Awel y Môr Offshore Wind Farm

Marine Mammal Clarification Note

Marine Licence Submission 1

Document Reference: ML-1.8

Figure 1: Population trajectory for both the impacted and un-impacted harbour porpoise population resulting from 201 days of piling disturbance

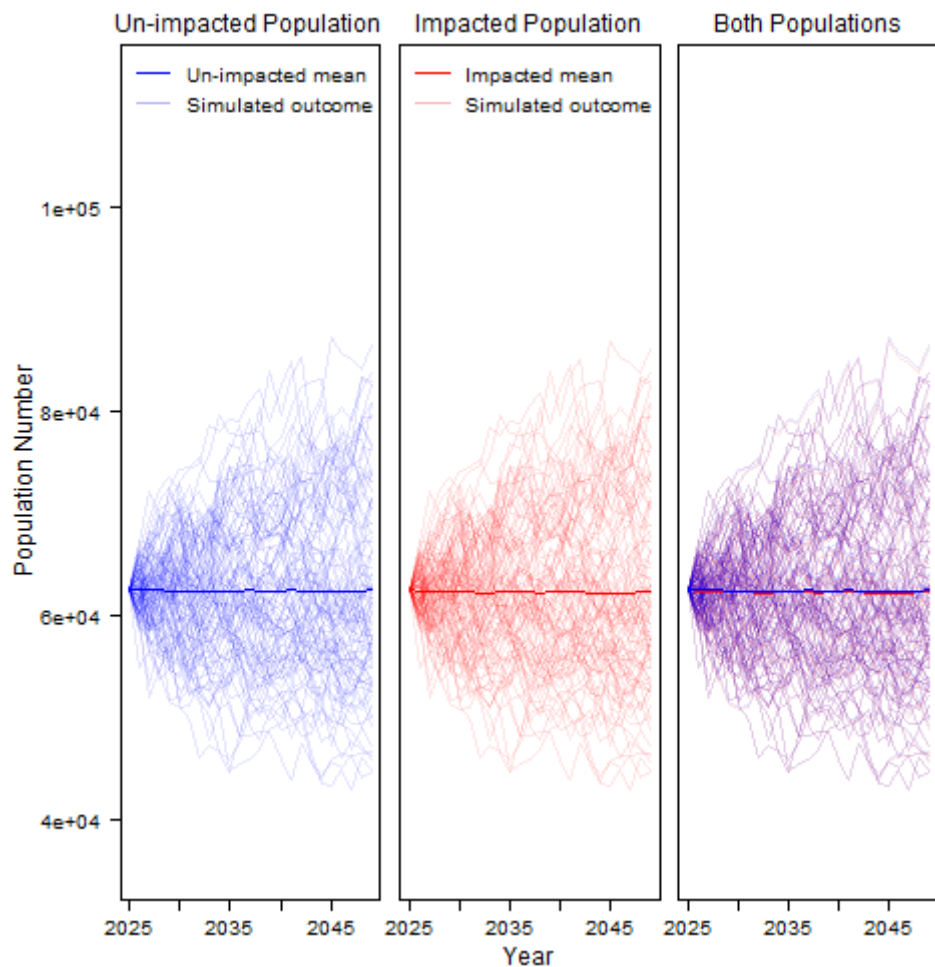
26 NRW stated: *"In order to allow a more comprehensive analysis of PTS and disturbance, NRW considers that additional modelling should be carried out and additional model details provided in order to inform assessments of underwater noise and PTS onset. This includes carrying out Interim Population Consequences of Disturbance (iPCoD) modelling for harbour porpoise disturbance and PTS injury, including modelling parameters used"*.

- 28 Using the SWF density estimate, the proportion of the MU predicted to be impacted reached 3.38%, however, since this density estimate was considered to be highly precautionary, iPCoD was not run. For completeness, this has now been run and the results presented here. The following parameters were used:

- ▲ Demographic parameters: as per Sinclair et al., (2020)
 - ▲ Disturbance to 2112 porpoise per day
 - ▲ 201 piling days
- 29 Even under this worst-case scenario (using the highly conservative density estimate), the population size of the impacted population remains as 99.9% of the size of the unimpacted population after 1 year of pile driving, and 99.8% of the size of the unimpacted population at the end of the 25-year simulation (Figure 1). The conclusions presented in the marine mammal impact assessment (ES Volume 2, Chapter 7; AS-026) therefore remain the same:
